ALE:	
AS SHOWN	LOWER HAIGHT TRAFFIC SIGNALS
OF	HAIGHT STREET AND FILLMORE STREET TRAFFIC SIGNAL PLAN

CONTRACT NO. 1000013166
DRAWING NO. $E-7.0$
FILE NO.
REV. NO.

CHANGE 3 BY PW 2264J HAIGHT PAVING, SEWER, & WATER PROJECT

TRAFFIC SIGNAL MODIFICATIONS
ETS	
71	FILLMORE ST & HAIGHT ST

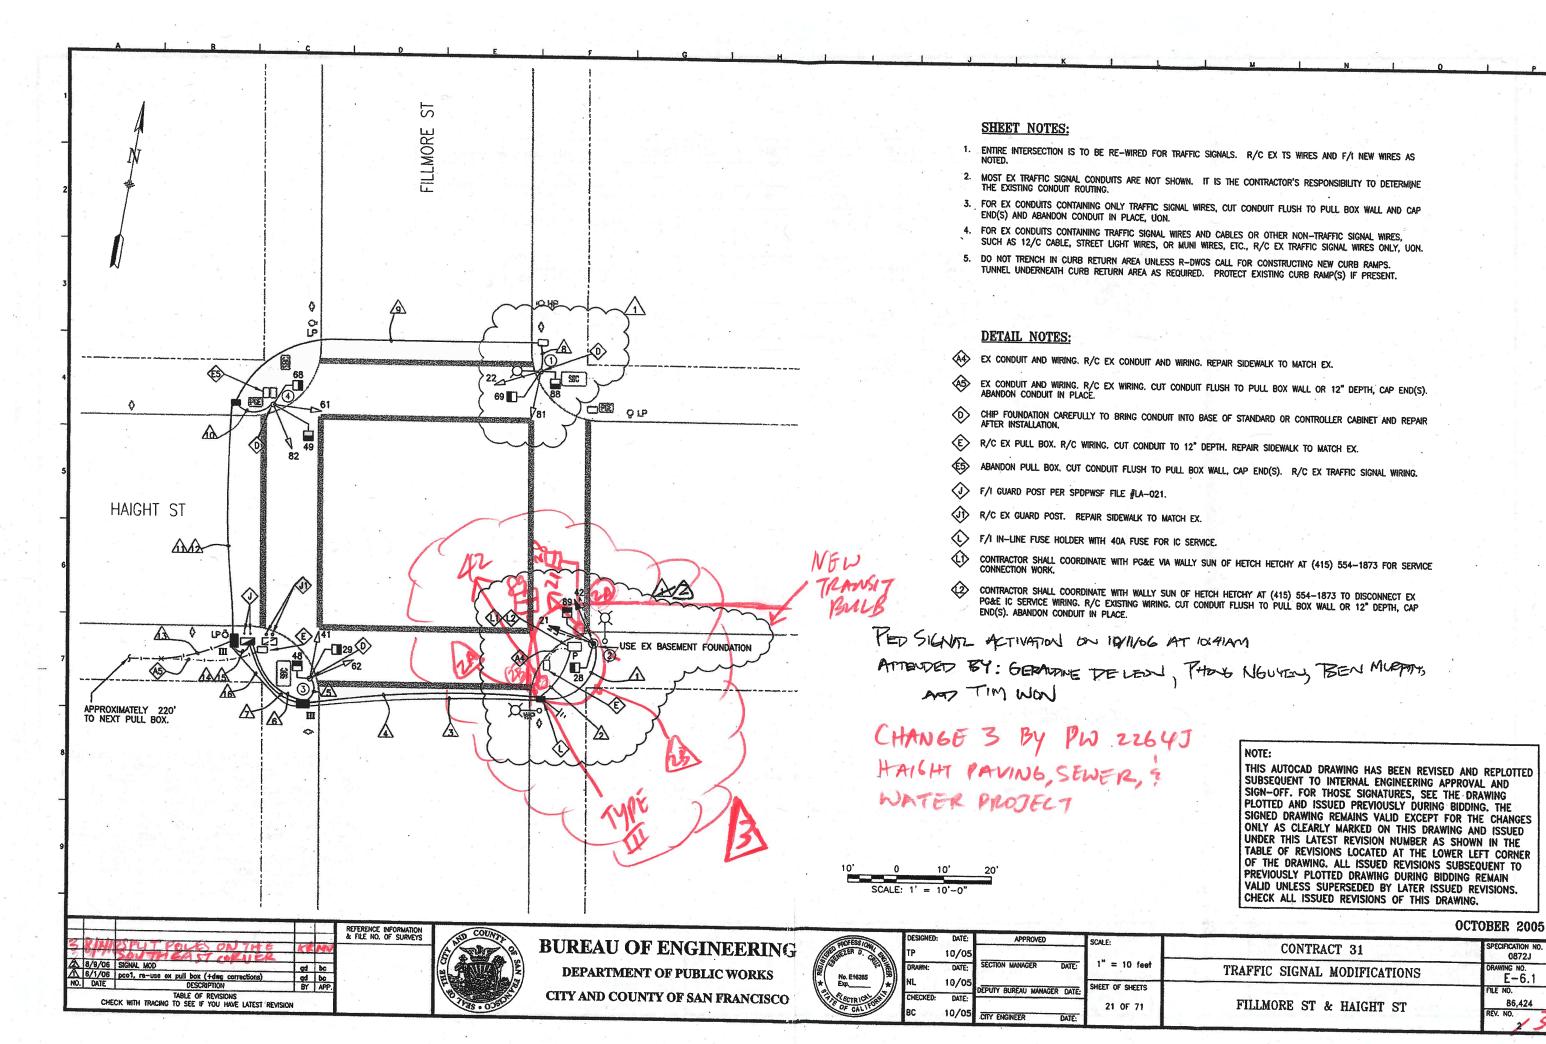
A ABANDON EXISTING CONDUIT. REFER TO GENERAL NOTES 21.

Signal modification work at NWC was completed on 4/2/2021 as part of Lower Haight project.
